Access Compliance Report

Public Rights-of-Way

Intersection ID: 29164	Main Street: GARRISON_RD	Cross Street: PURPLE_BLOOM_LN	Location: N
ADA ID: 68819A9E065B	Ramp Type: PerpDiag	Initial Pass/Fail: Fail	Overall Compliance: No
			Severity Score: 33.75

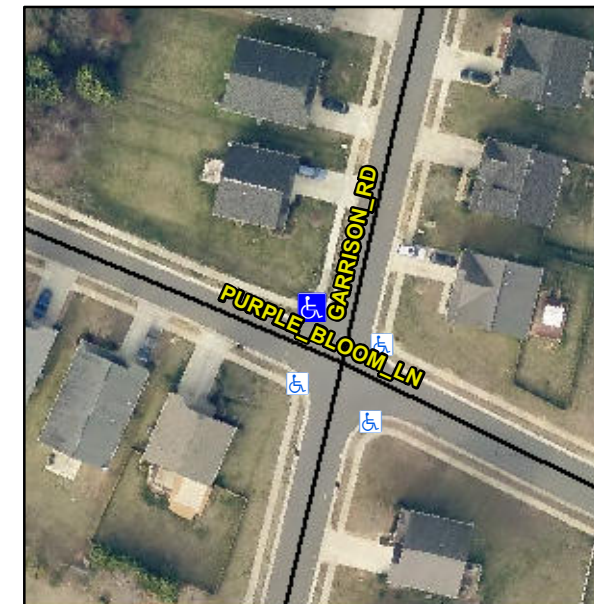
Not Found, R304.5.1, R304.5.3

Compliance	Description	Data	Compliance	Description	Data
N/A	Ramp Length (in)	49.0	Yes	Ramp Slope (%)	7.4
No	Ramp Width (in)	41.0	No	Ramp XSlope (%)	11.5
N/A	Flare Type LT	N/A	N/A	Flare Type RT	N/A
N/A	Flare Slope LT (%)	N/A	N/A	Flare Slope RT (%)	N/A
N/A	Flare Traversable LT?	N/A	N/A	Flare Traversable RT?	N/A
N/A	Landing Length (in)	N/A	N/A	DWS Provided?	N/A
N/A	Landing Width (in)	N/A	N/A	DWS Contrast?	N/A
N/A	Landing Slope (%)	N/A	N/A	DWS Length (in)	N/A
N/A	Landing X Slope (%)	N/A	N/A	DWS Full Width?	N/A
N/A	Landing Curb? (Y/N)	N/A	N/A	DWS Offset (in)	N/A
N/A	Shared Landing?	N/A			
N/A	Gutter Ponding?	N/A	N/A	Gutter Slope (%)	N/A
N/A	Gutter Lip Ht (in)	N/A	N/A	Gutter X Slope (%)	N/A
N/A	Painted X Walk1?	No	N/A	Painted X Walk2?	No
	X Walk 1 Direction	To SW		X Walk 2 Direction	To SE
N/A	X Walk 1 Width (in)	N/A	N/A	X Walk 2 Width (in)	N/A
	X Walk 1 Slope (%)	7.1		X Walk 2 Slope (%)	1.0
	X Walk 1 X Slope (%)	1.3		X Walk 2 X Slope (%)	7.5

Remove & Replace Curb Ramp With Two New Directional Ramps or Equivalent.
